Re: Submission to State Significant Development No. SSD7684

Site: 241-249 Wheat Road, Cockle Bay

Proposal / Proposed Development: Stage 1 Concept ('Built Form Envelope')

Submission on behalf of: Tianlong Ribbon Pty Ltd (Future Owners of 'The Ribbon Hotel' at 31 Wheat Road)

Figure 1: FJMT Report p.84 3D Views of Building Envelope.

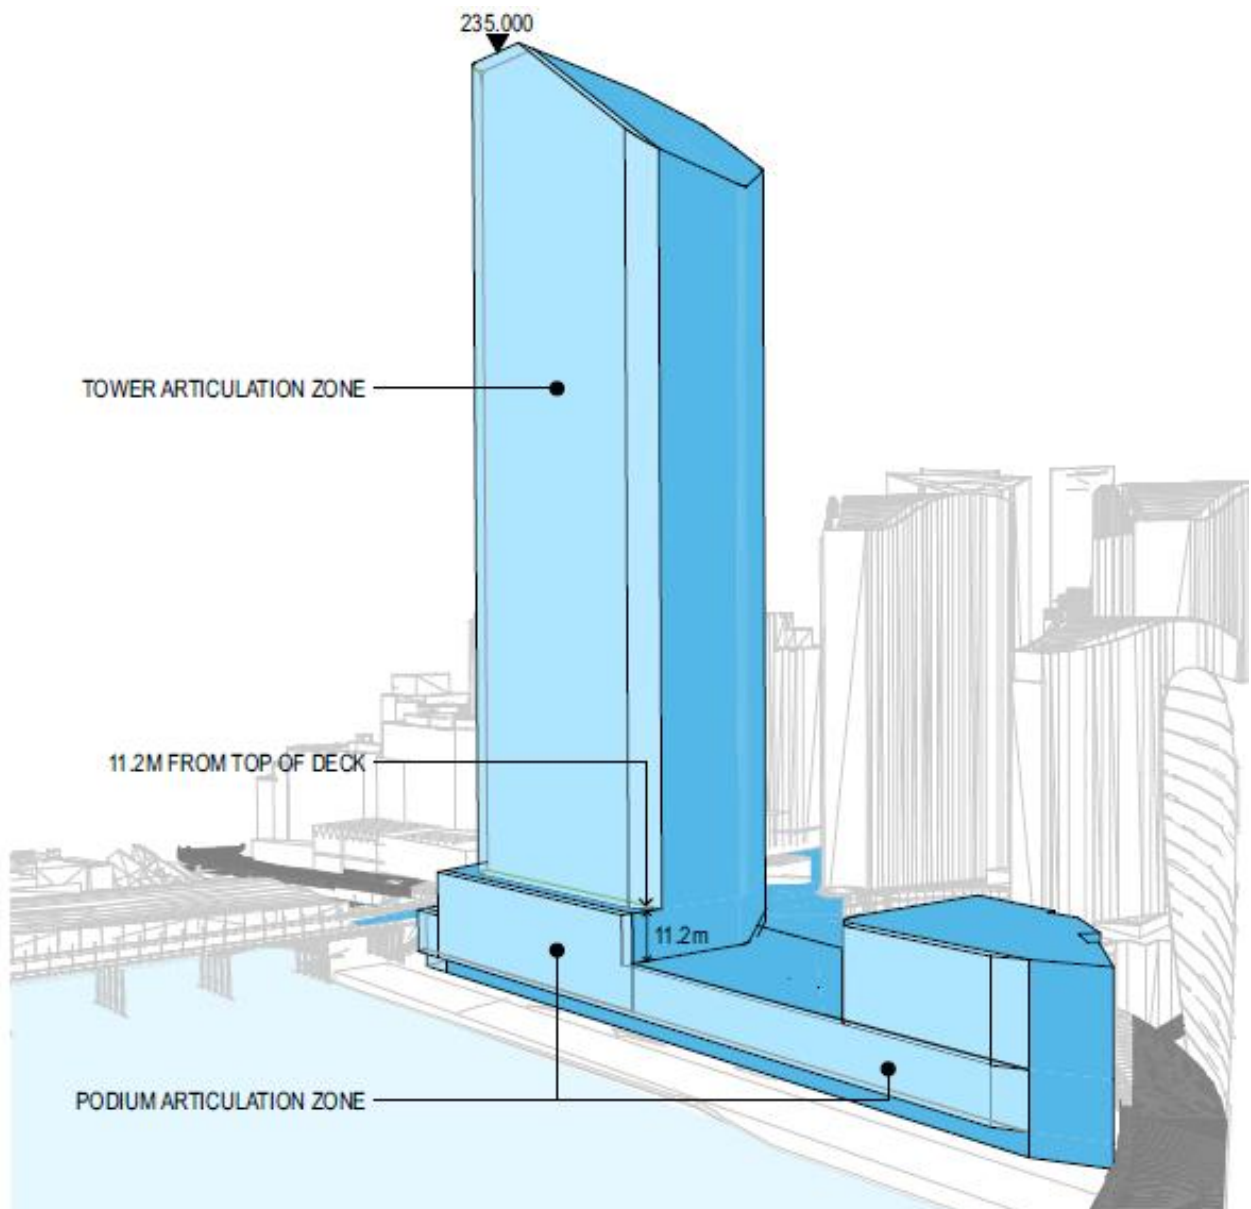
This submission is the Proposed Development, particularly the podium and tower building envelope (see Figure.1 below) is excessive for the following reasons (addressed in more detail in sections below):

- 2.1. The **Podium envelope** extends over vital public open space to the south of the existing Druitt Street pedestrian overbridge and is too close to the 'southern boundary' and adjacent development. This will impact on connectivity and views from Druitt Street/ Wheat Road through to Cockle Bay and The Ribbon Hotel and is an overdevelopment of public land in this location.
- 2.2. The **Southern Pavilion or Tower envelope** is located too close to the 'southern boundary' and adjacent development, blocks connections and sight-lines from Druitt Street to Cockle Bay, and it will overshadow the public domain of Cockle Bay waterfront and The Ribbon Hotel.

2.3. The **Northern Tower envelope** is excessive in that it is:

- a) located too close to the waterfront and impacts on the 'human scale' and amenity of the waterfront promenade / public domain;
- b) too high and the height is inconsistent with surrounding building heights and the CBD skyline, not suitable for this location on the Harbour, not required to create a 'gateway' development, and produces unacceptable impacts on the public domain and surrounding development;
- c) too bulky and of an excessive dimension to support the intended tower floor plates;
- d) inconsistent with the adopted planning policies and strategic direction for Cockle Bay and surrounding development, particularly relating to building heights in close proximity to the waterfront;
- e) has potential to create significant wind and shadow impacts on the public domain and adjacent buildings to the south.

2.4. The **overall building envelope** is excessive, does not integrate with the context or city skyline, and inconsistent particularly with the requirements of the Sydney Regional Environmental Plan (Sydney Harbour Catchment) 2005 Aims including, but not limited to,

Figure 2: FJMT Report P.78 Market Street Section Study (Proposal in Red)

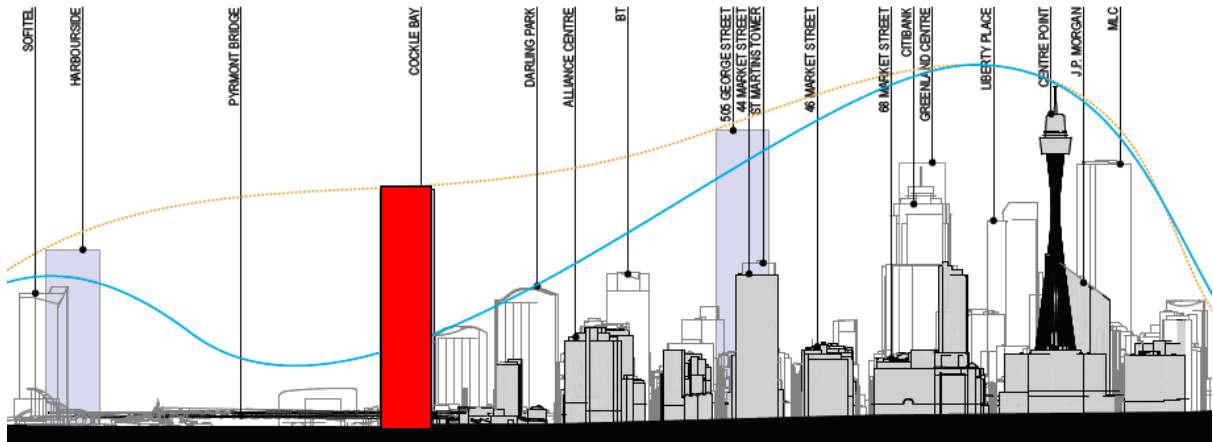
9.1. The Northern Tower is inconsistent with the CBD Skyline and creates an unacceptable visual impact that is not properly addressed in the JBA Visual Impact Assessment.

- 9.2. The justification for a 'modified' skyline (see Figure.2 above) is weak and shows little relationship to the Darling Harbour 'valley' or stepping down of building heights towards Cockle Bay.

- 9.3. The surrounding context on the western edge of the CBD is predominantly a height of 80m (City of Sydney Submission 16/6/16). Whilst the Subject Site may be outside the City of Sydney Planning Controls this context is relevant to height and scale.

Figure 7: Section A showing an East-West Section through the Northern Tower.

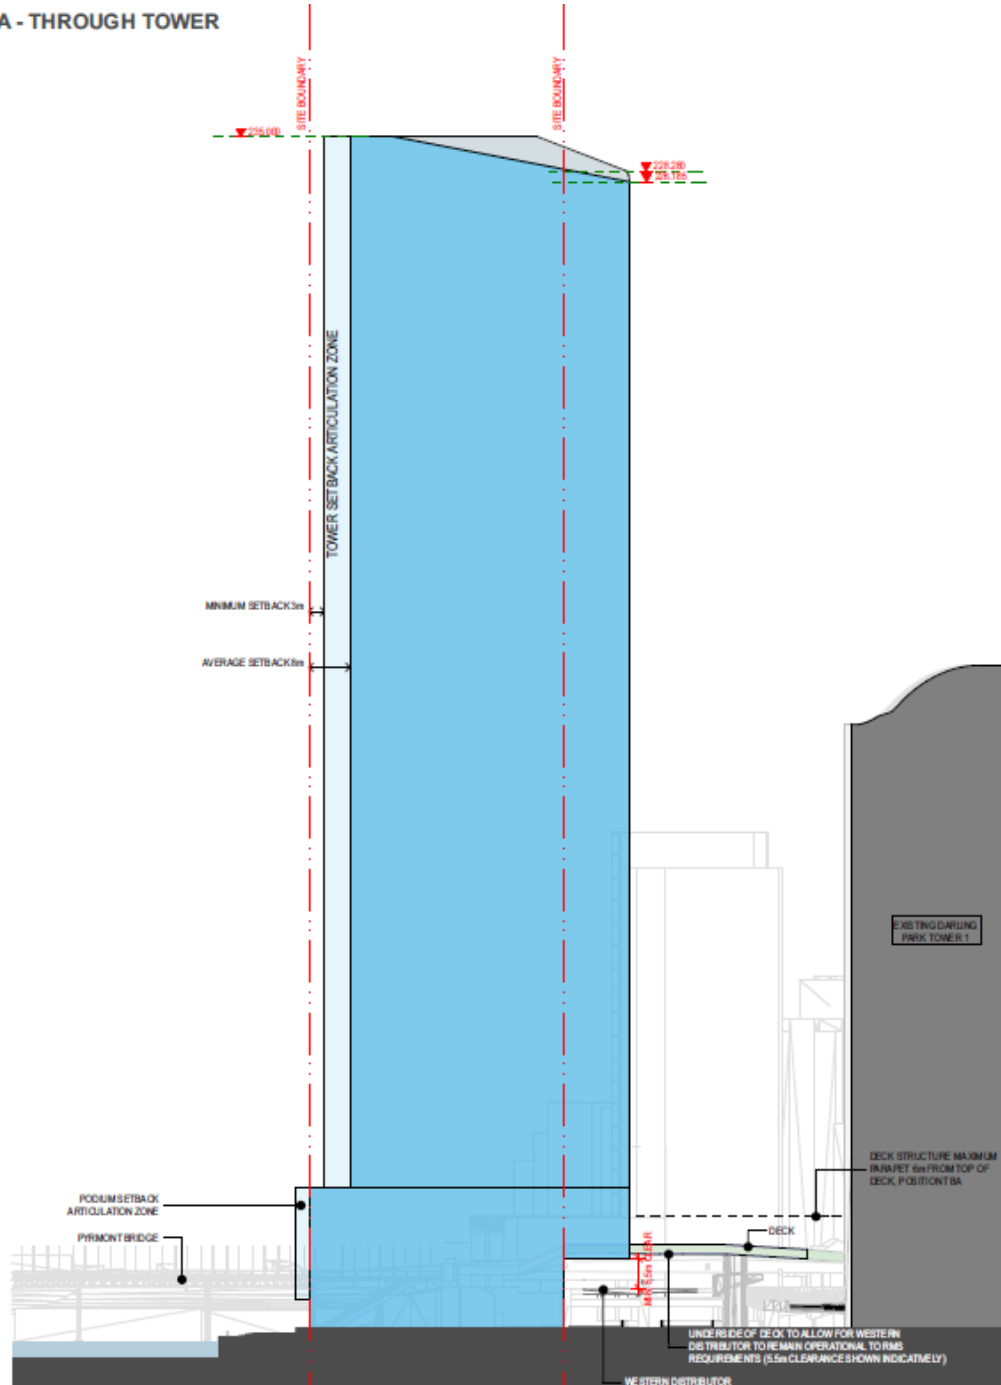
- 11.1. As stated above, the front (western) façade of the tower envelope extends to within 3m of the site boundary (accepting that a further 5m setback may contain articulation) and extends up to 232.7m above the waterfront promenade / deck.

- 11.3. Section A (Figure.7 below) provides an east-west section through the tower back to the CBD in which the tower envelope can be seen to ‘dwarf’ the waterfront promenade in height, depth, bulk and scale (see also Figure.6 above). A 3-8m setback above the podium would have little impact in terms of mitigating the tower dominating the waterfront.

- 14.5. The northern tower envelope:
 - a) Should be setback at least 6-8m from the western (waterfront) site boundary;
 - b) Floor plate should be reduced to more closely resemble the tested building scenarios (maximum dimension of 65-70m enforced) and reduce the risk of additional bulk, scale and associated impacts;

Figure 8: Shadow diagrams for 11am and 12pm (FJMT Report p.90).

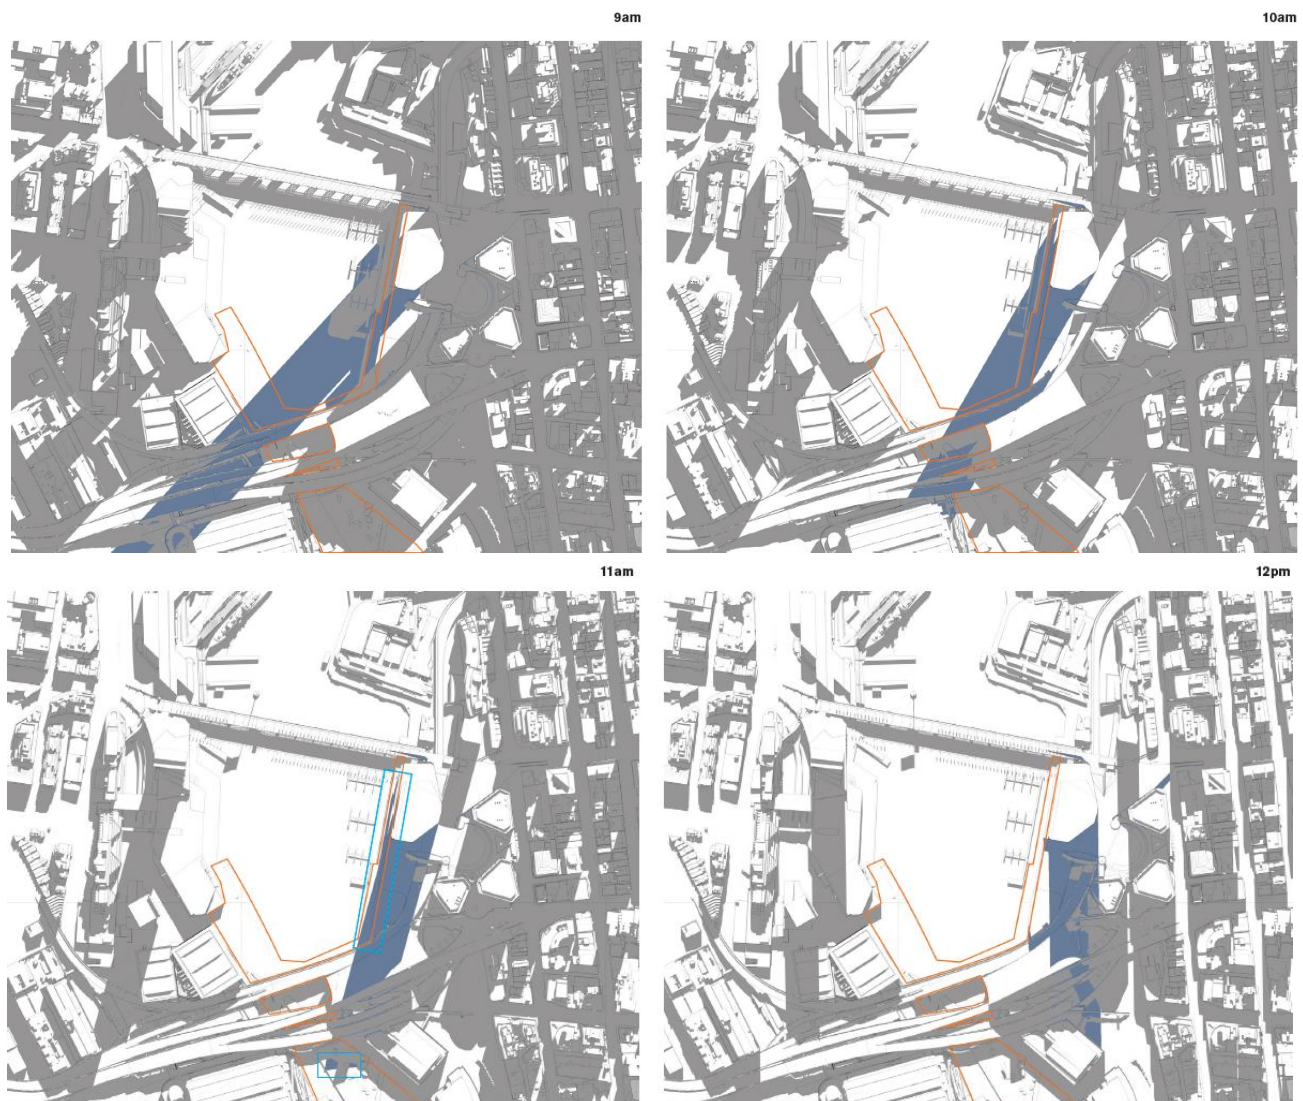
- 12.2. The location of the Site and the Northern Tower means that there be significant shadow impacts on Cockle Bay, especially the public domain adjacent or near to The Ribbon Hotel, for the entire morning (see Figure.8 below). Existing building heights along the western edge of the CBD have been specifically designed to minimise these impacts so the proposal is distinctly inconsistent with this important public domain principle.

- 12.3. The FJMT Report (Section 4 Urban Design Controls p.90) attempts to show how the proposal will protect mid-Winter lunchtime sun plane to Tumbalong Park, but provides little review of the impact on the public domain and pedestrian comfort levels along the waterfront as well as adjacent development to the south, such as The Ribbon Hotel.

- 12.4. Whilst this is a 'maximum' envelope study it is difficult to assess how that envelope will be filled to determine the extent and duration of over-shadowing at key points of the day.
